ADDENDUM NO. 1

April 14, 2022

YOST ELEMENTARY SCHOOL ADDITIONS AND RENOVATIONS Chesterton, IN 46304

Addendum One (AD.01) to the drawings and specifications prepared by Gibraltar Design for **New Yost Elementary School** for Duneland School Corporation, Chesterton, Indiana.

A-860

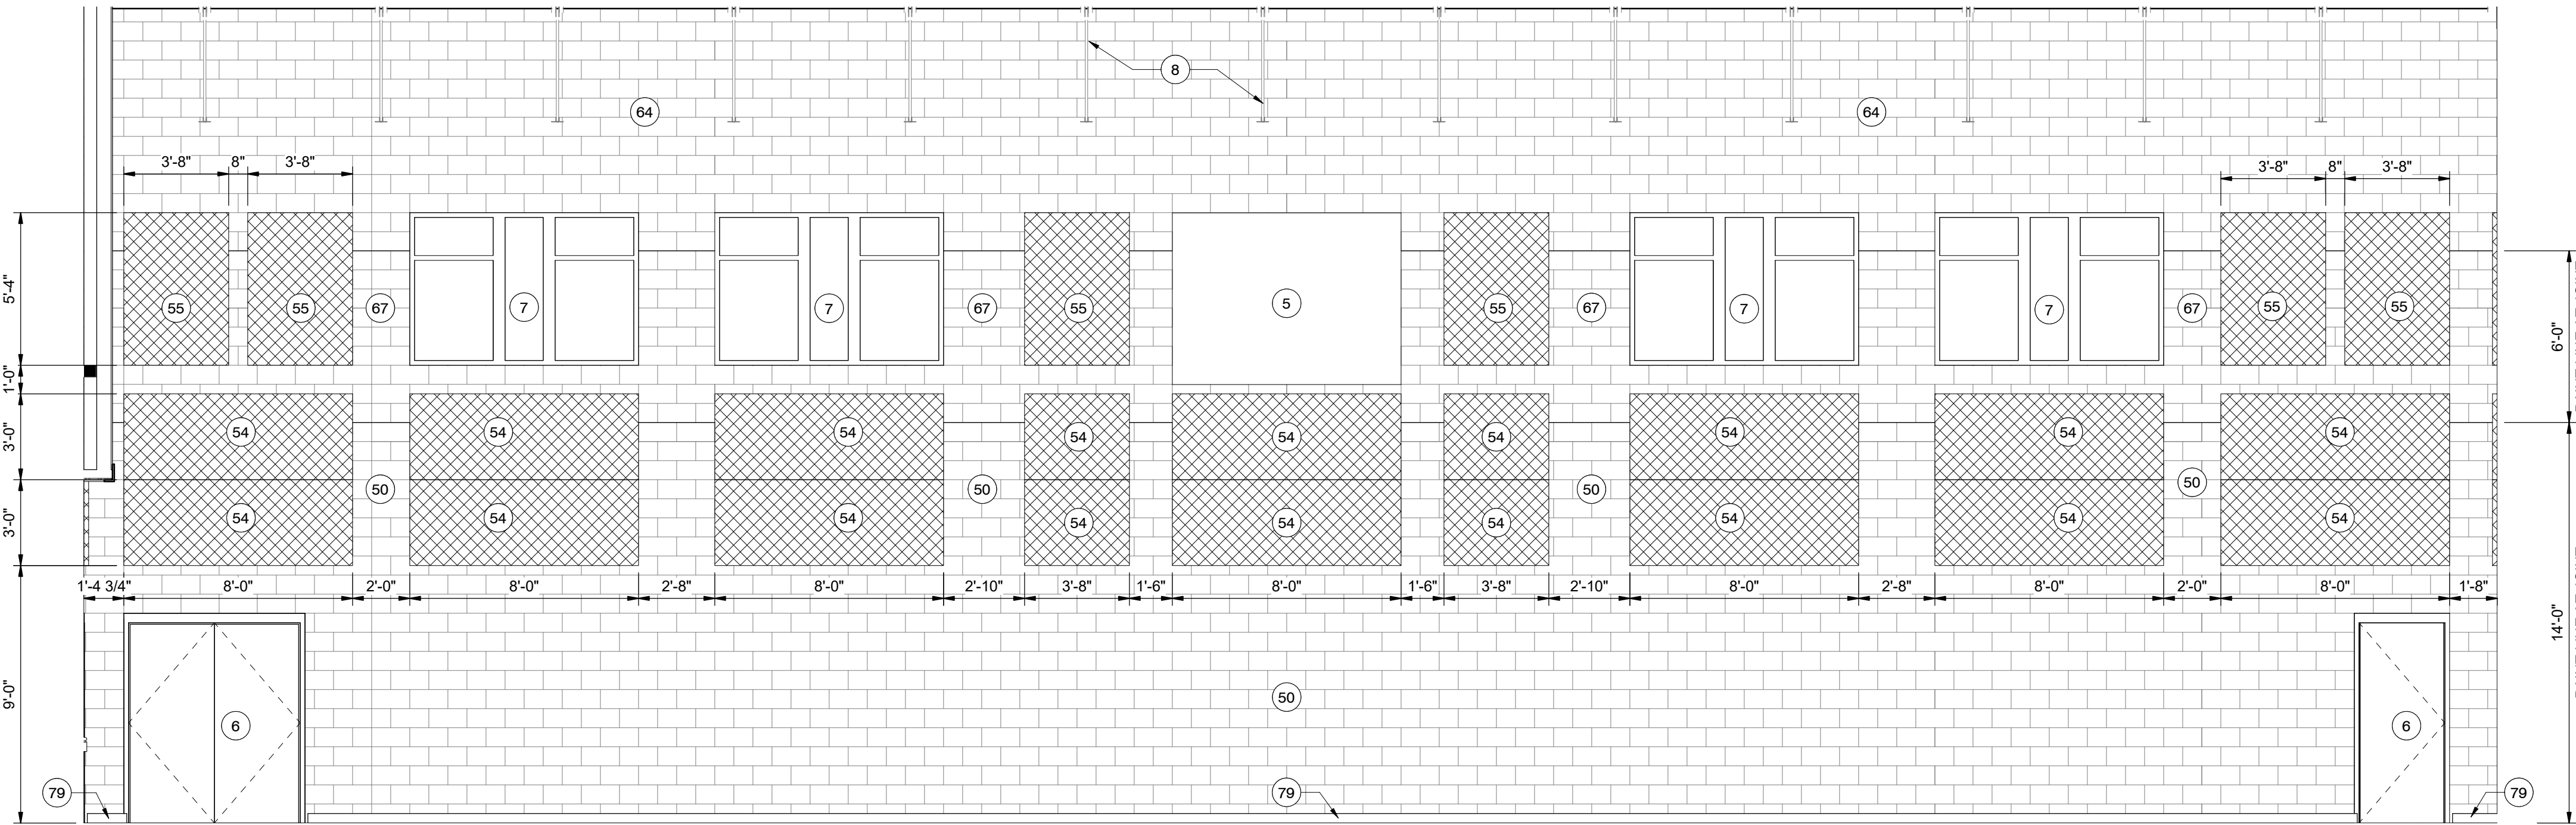
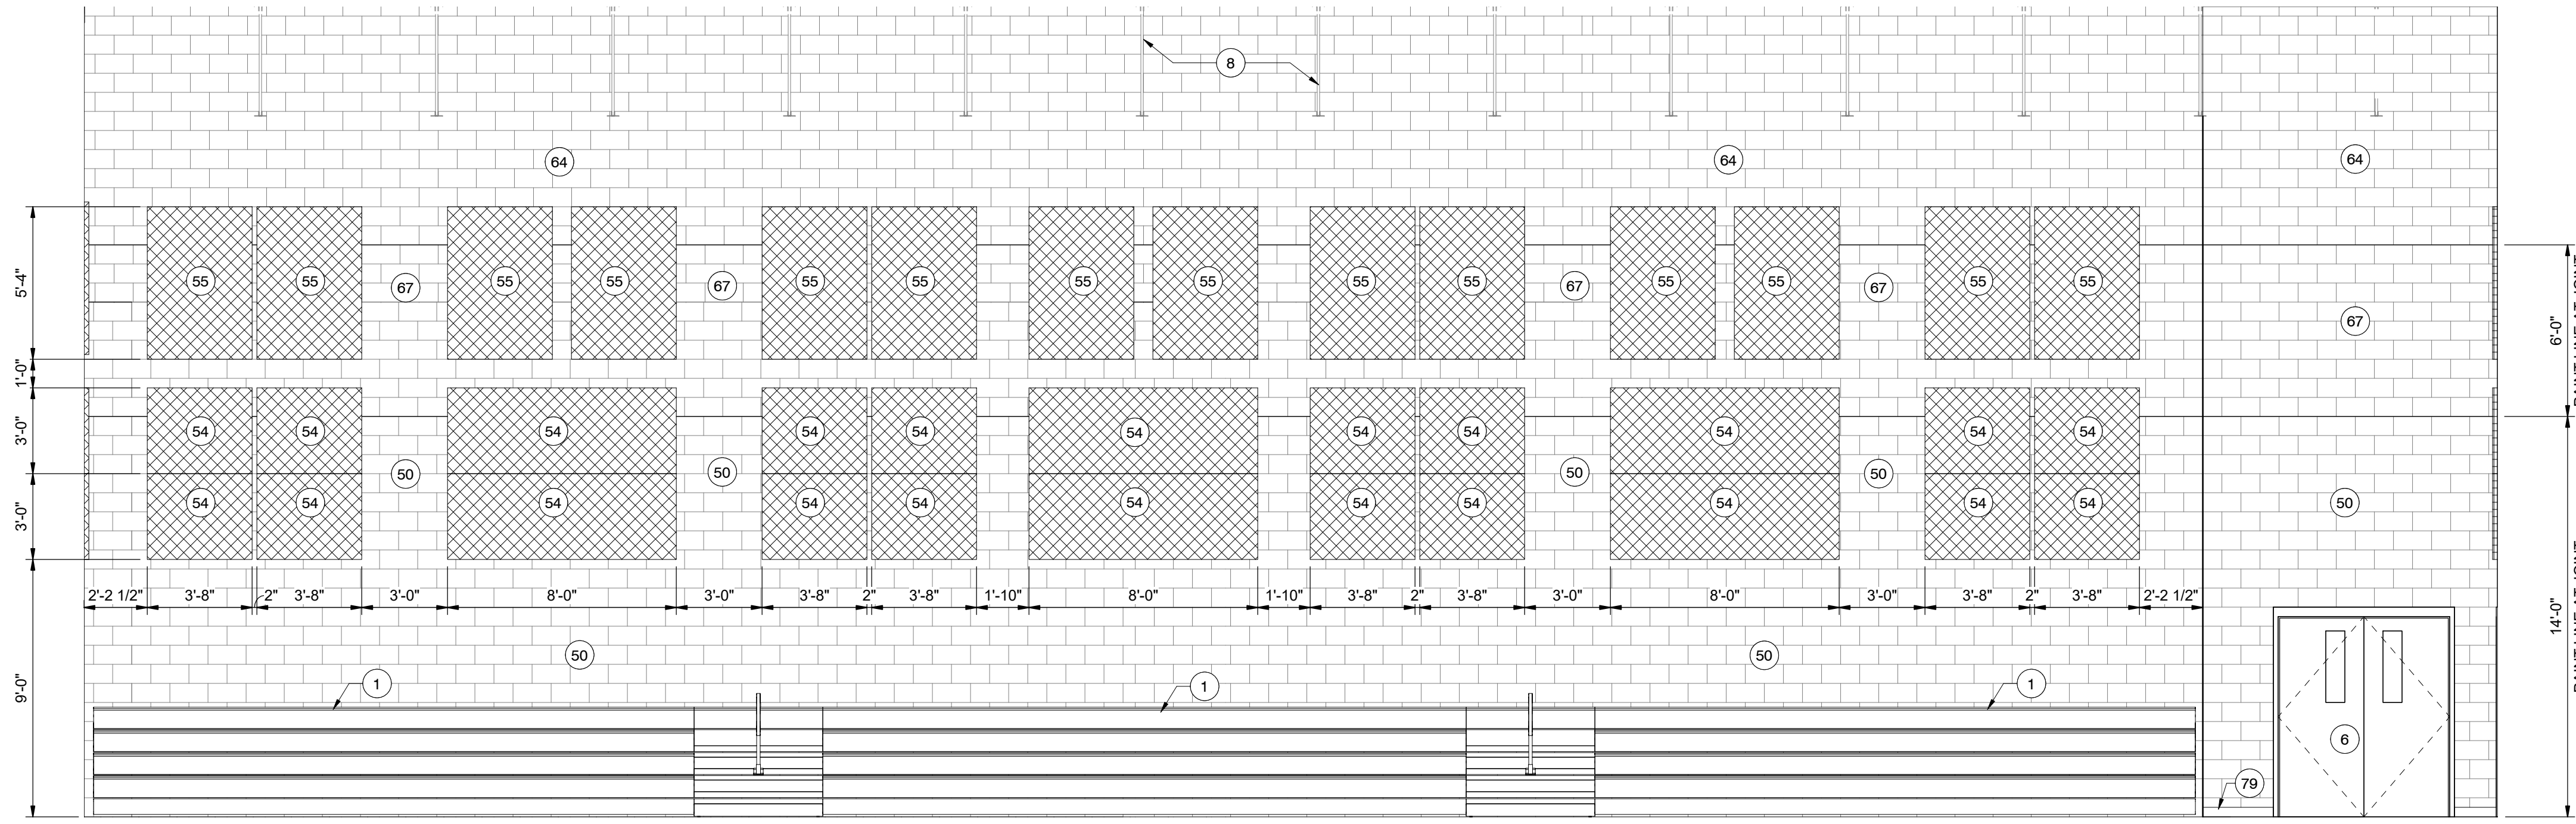
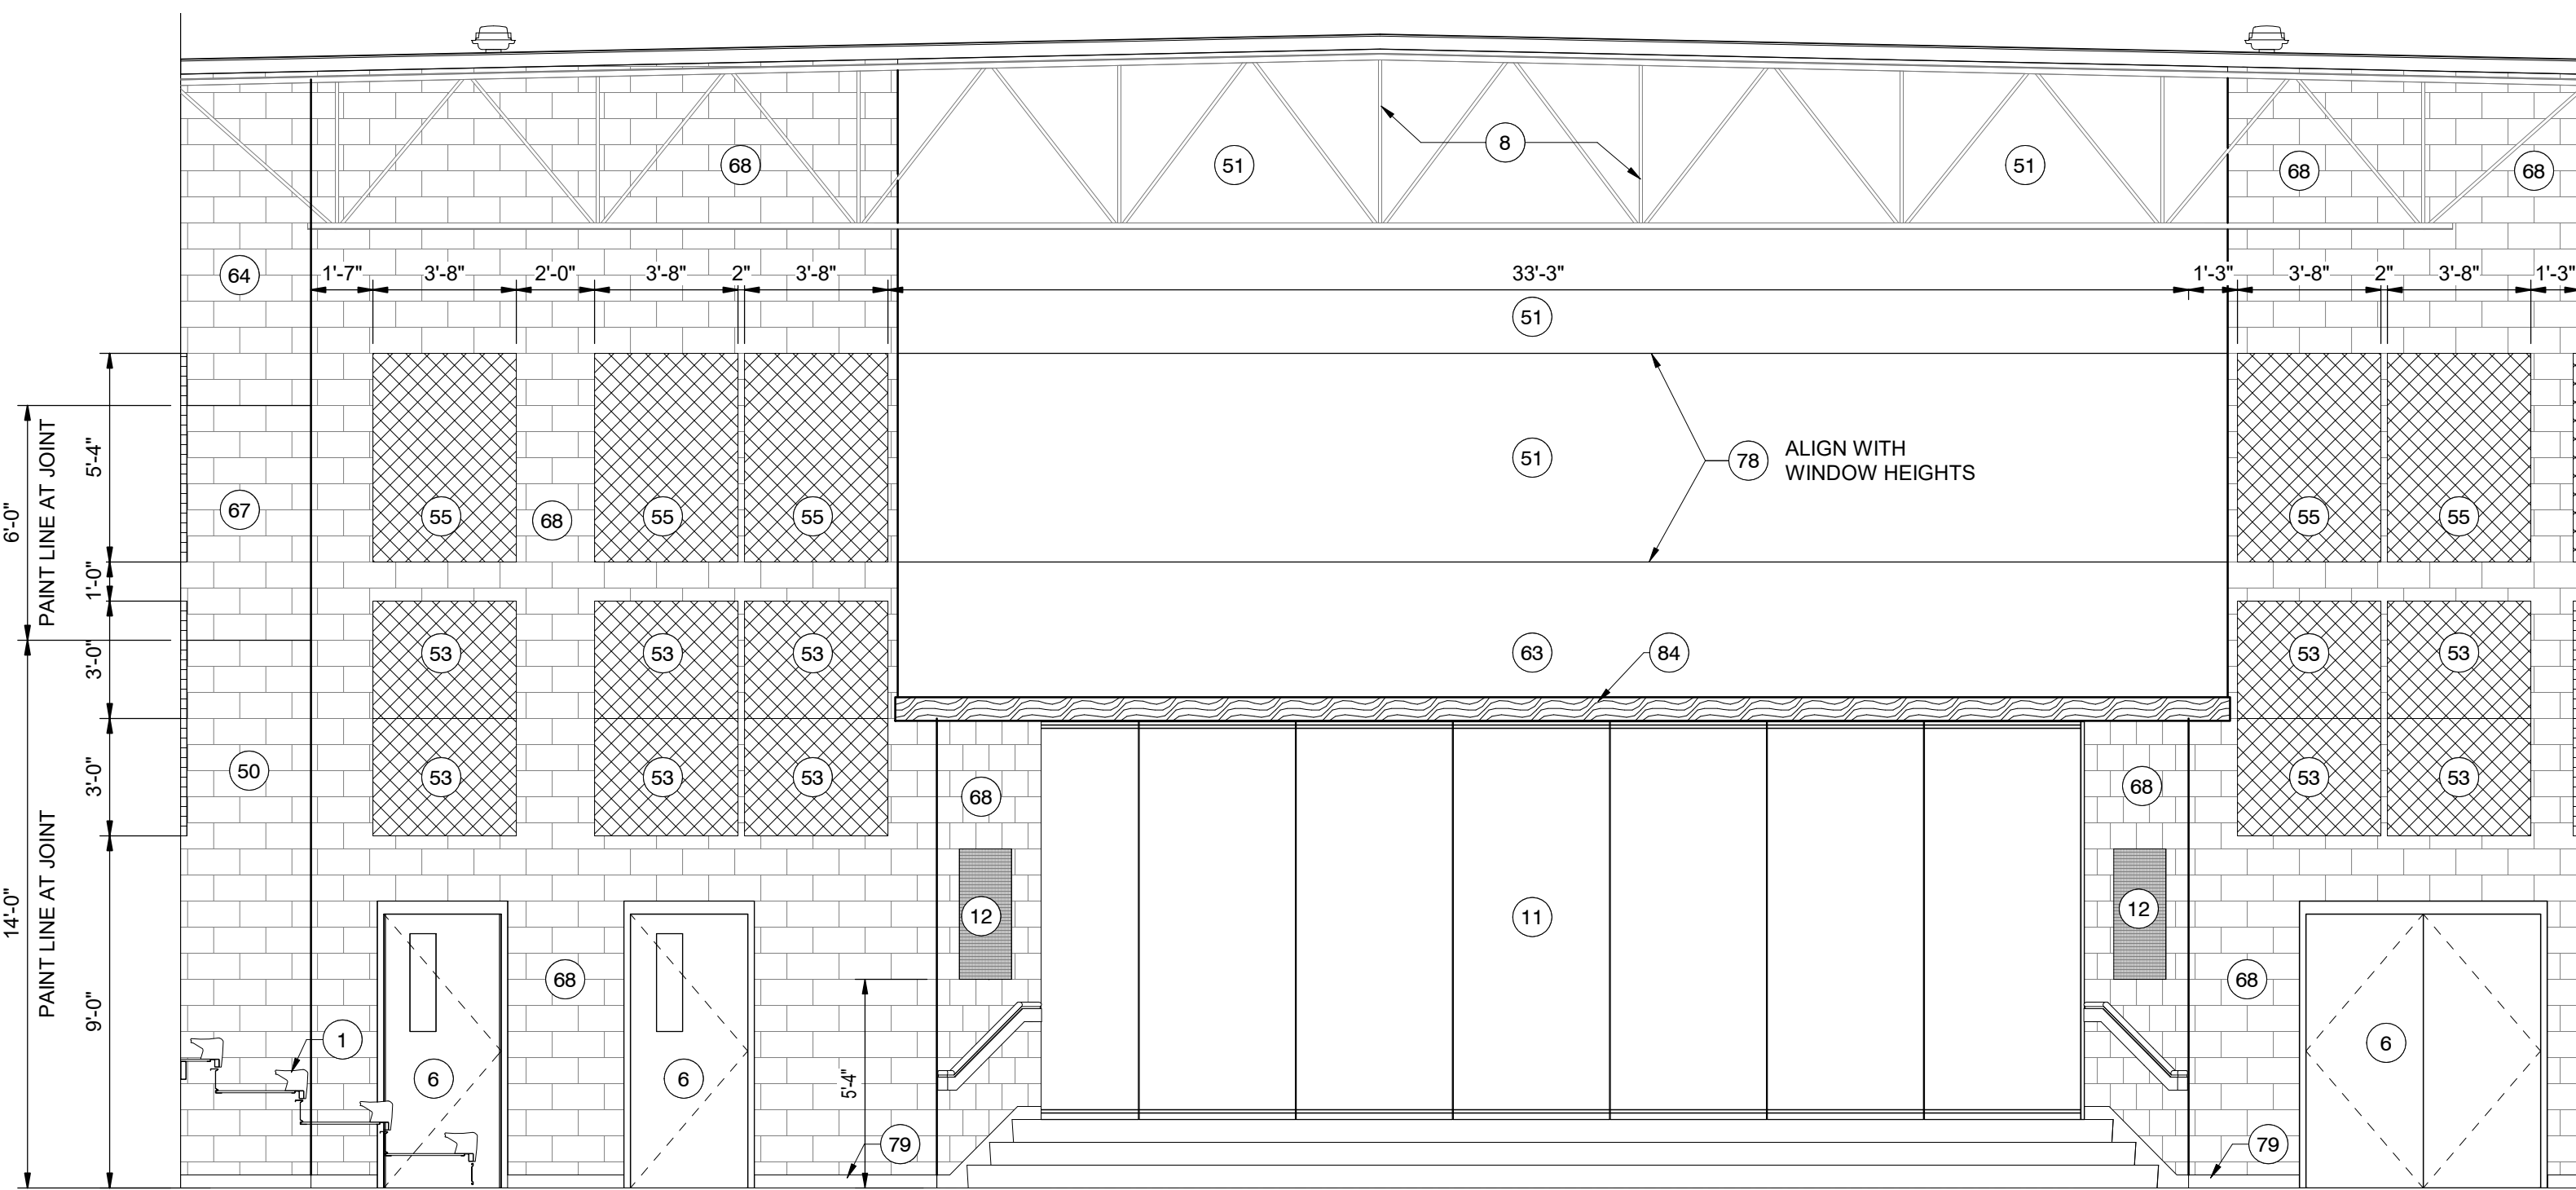
27. Sheet A-860

- A. Refer to revised full size drawing, included in this Addendum, for Interior Elevation Key Note #4 changed - Add "School Graphic TBD" to wainscot wall padding.
